Dresden Nuclear Power Station, Units 2 and 3
Renewed Facility Operating License Nos. DPR-19 and DPR-25
NRC Docket Nos. 50-237 and 50-249

Subject: Third Six-Month Status Report in Response to March 12, 2012 Commission Order Modifying Licenses with Regard to Requirements for Mitigation Strategies for Beyond-Design-Basis External Events (Order Number EA-12-049)

**Third Six-Month Status Report for the Implementation of Order EA-12-049, Order
Modifying Licenses with Regard to Requirements for Mitigation Strategies for Beyond-
Design-Basis External Events**

MAAP Calculation of RPV Pressure During RPV Depressurization

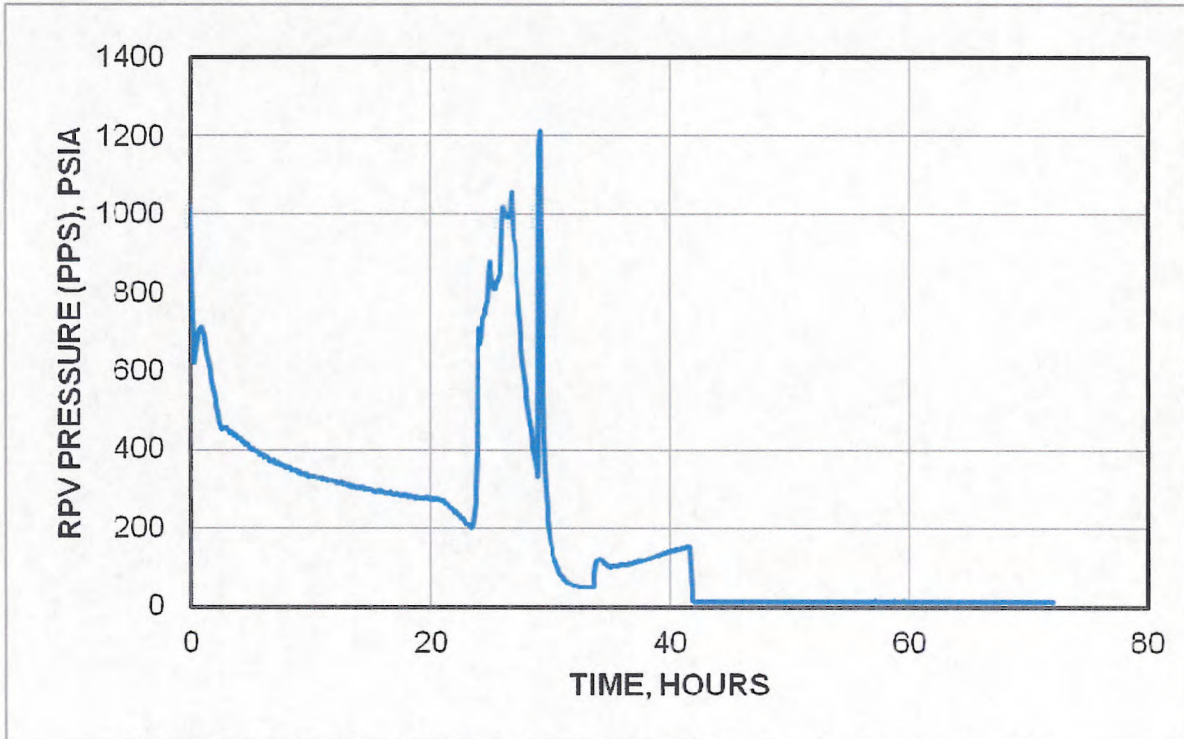
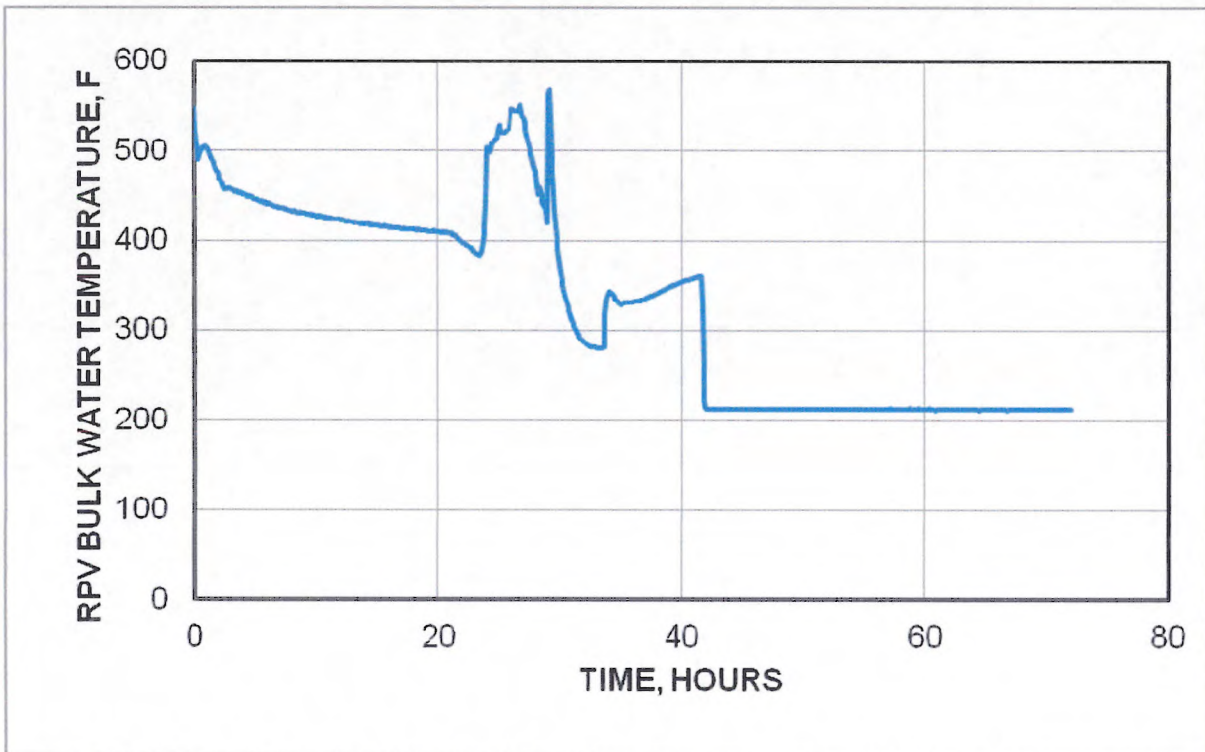
ITEM (NOTE – this item corresponds to NRC Interim Staff Evaluation CONFIRMATORY action item 3.2.1.1.B of the Dresden evaluation)

- (2) *The collapsed level must remain above Top of Active Fuel (TAF) and the cool down rate must be within technical specification limits.*

Attachment 1A of the updated Dresden Integrated Plan (Aug 2013) indicates that Dresden will utilize the isolation condenser for RPV pressure control which will not exceed the technical specifications limit for RPV cooldown of 100°F/hr. The following plots of the bulk RPV water temperature and RPV pressure from the MAAP analysis confirms this cooldown criteria for the supporting MAAP calculation. Note that the Dresden Integrated Plan does not credit external RPV injection prior to core uncover in the MAAP analysis. This modeling assumptions leads to unrealistic spikes in RPV pressure and RPV bulk water temperature due to the core being uncovered after approximately 20 hours. It is expected that successful core cooling and prevention of the RPV collapsed water level dropping below TAF would be shown when external RPV injection is included in the calculation. This would avoid these unrealistic assessments after the IC becomes ineffective.

MAAP Calculation of Collapsed RPV Water Level Inside the Shroud

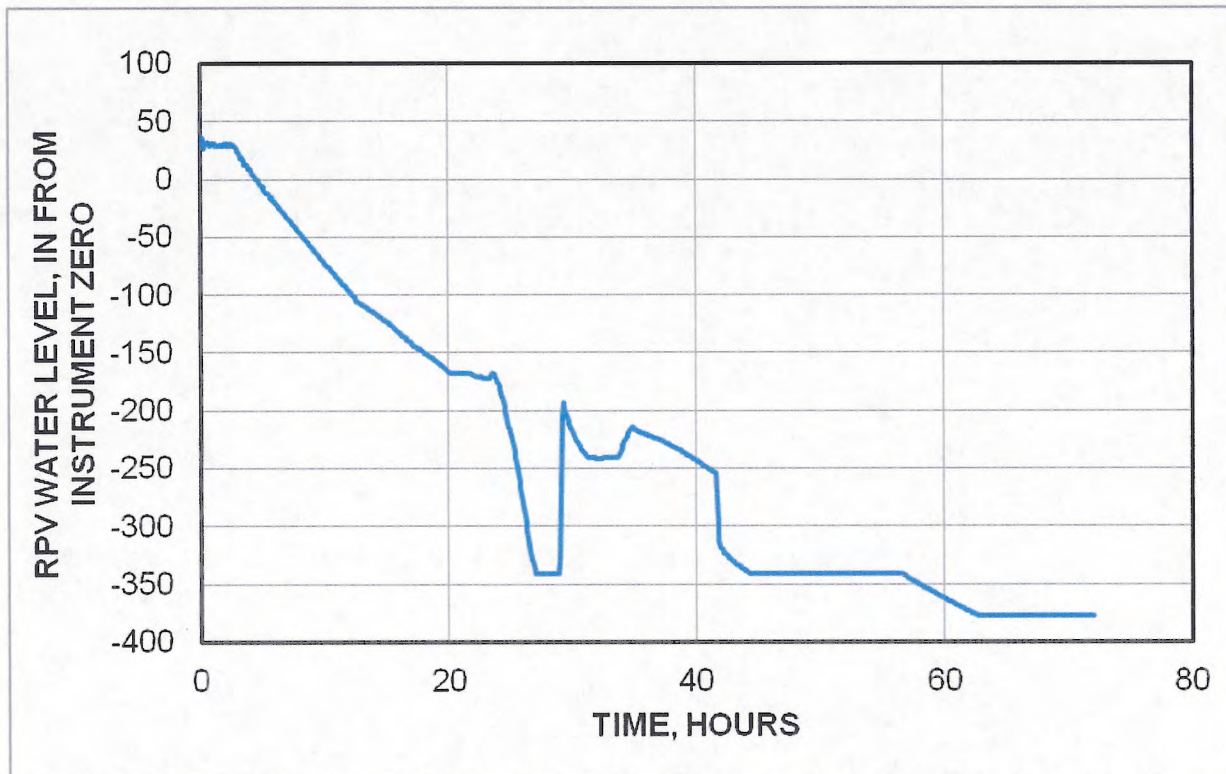
- (5) *The specific MAAP4 analysis case that was used to validate the timing of mitigating strategies in the integrated plan must be identified and should be available on the ePortal for NRC staff to view. Alternately, a comparable level of information may be included in the supplemental response. In either case, the analysis should include a plot of the collapsed*

vessel level to confirm that TAF is not reached (the elevation of the TAF should be provided) and a plot of the temperature cool down to confirm that the cool down is within tech spec limits.

For the representative MAAP run (Case 9), the collapsed RPV water level inside the shroud drops below TAF and remains below TAF for the duration of the analysis. The plot below shows that the lowest RPV level, calculated by MAAP, was far below instrument zero. Instrument zero is at +503" above vessel zero. TAF is located at -143" relative to instrument zero. The Dresden analysis cites the use of external FLEX pump make-up to the RPV prior to the collapsed RPV water level dropping below TAF which would prevent the core from being uncovered.

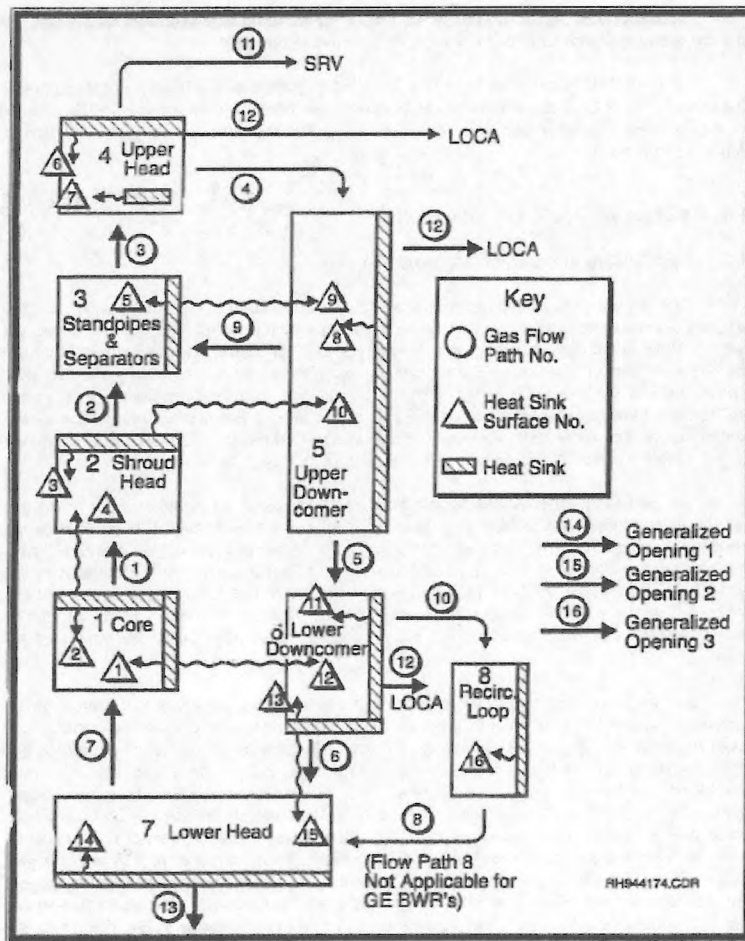
(4) *In using MAAP4, the licensee must identify and justify the subset of key modeling parameters cited from Tables 4-1 through 4-6 of the "MAAP4 Application Guidance, Desktop Reference for Using MAAP4 Software, Revision 2" (Electric Power Research Institute Report 1020236). This should include response at a plant-specific level regarding specific coding options and parameter choices for key models that would be expected to substantially affect the ELAP analysis performed for that licensee's plant. Although some suggested key phenomena are identified below, other parameters considered important in the simulation of the ELAP event by the vendor / licensee should also be included.*

- a. Nodalization*
- b. General two-phase flow modeling*
- c. Modeling of heat transfer and losses*
- d. Choked flow*
- e. Vent line pressure losses*
- f. Decay heat (fission products / actinides / etc.)*

- a. The reactor vessel nodalization is fixed by the MAAP code and cannot be altered by the user, with the exception of the detailed core nodalization. The Dresden MAAP 4.0.5 parameter file divides the core region into 5 equal volume radial regions and 13 axial regions. The axial nodalization represents 10 equal-sized fueled nodes, 1 unfueled node at the top, and 2 unfueled nodes at the bottom. The figure below, taken from the MAAP Users Manual, illustrates the vessel nodalization scheme.
